DESIGN SPECIFICATION

ACCESSIBILITY

Penrith City Council C/- Justin Long Design

Emu Plains Village – 4 Lawson Street, Emu Plains

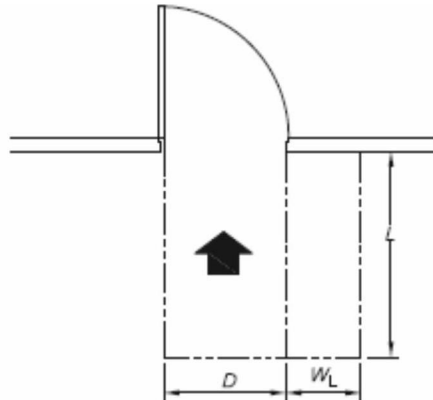
- (a) Whilst a compliant doorway opening is proposed between the new kitchenette and the deck area, the existing doorway opening from the hall into the new kitchenette space has not been provided with latch side circulation space, on the kitchenette side of the doorway opening
- (b) The proposed ramp shall have a length longer than 9-metres without an intermediate landing
- (c) No solid pathway is depicted between the base of the proposed ramp to the deck and any accessible car space or pedestrian entries to the site from the allotment boundaries
- (d) The balustrade to perimeter of the new deck and the ramp need be designed and constructed to AS 1428.1-2009, as includes the provision of kerb rails
- (e) The clear space inside the kitchen at the north-eastern corner of the floor appears less than 1540-mm wide (see above excerpt from AS 1428.1-2009)

- (f) Neither of the existing door openings from the new deck into the main hall space are depicted as having compliant latch side circulation space, on the new deck side of the doorway openings (see below excerpt from AS 1428.1-2009)

- (g) The wall enclosing the kitchen in the north-east corner of the floor, shall encroach upon the circulation space required for the modified doorway opening between that area and the office (see above excerpt from AS 1428.1-2009)

Diagram 4.3.1

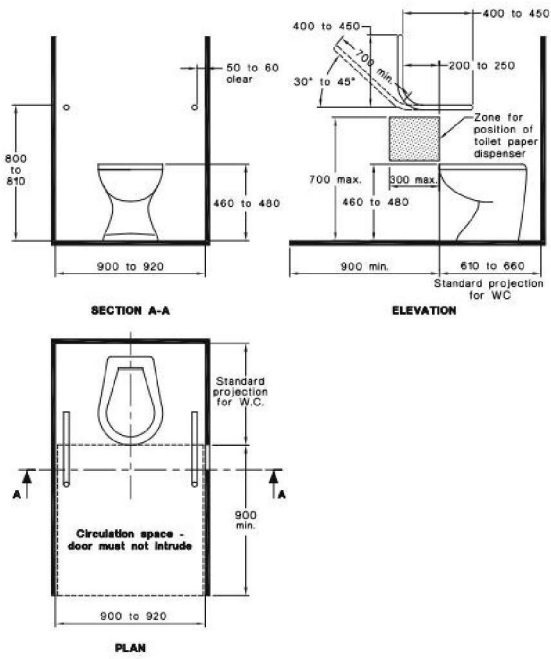
- (a) The doorway opening into the new cubicles opening directly into the hall space need be redesigned so as to be screened from view (from persons inside the hall)
- (b) The ambulant cubicle opening into the hall space does not comply with AS 1428.1-2009 (see figure 4.3.1 below) given the width of the enclosure exceeds 920-mm and grab rails are not provided to both sides of the WC pan
- (c) Ensure that the doorway opening to the new accessible toilet adjacent to the kitchen is not recessed more than 300-mm back from the line of the wall behind the wash basin
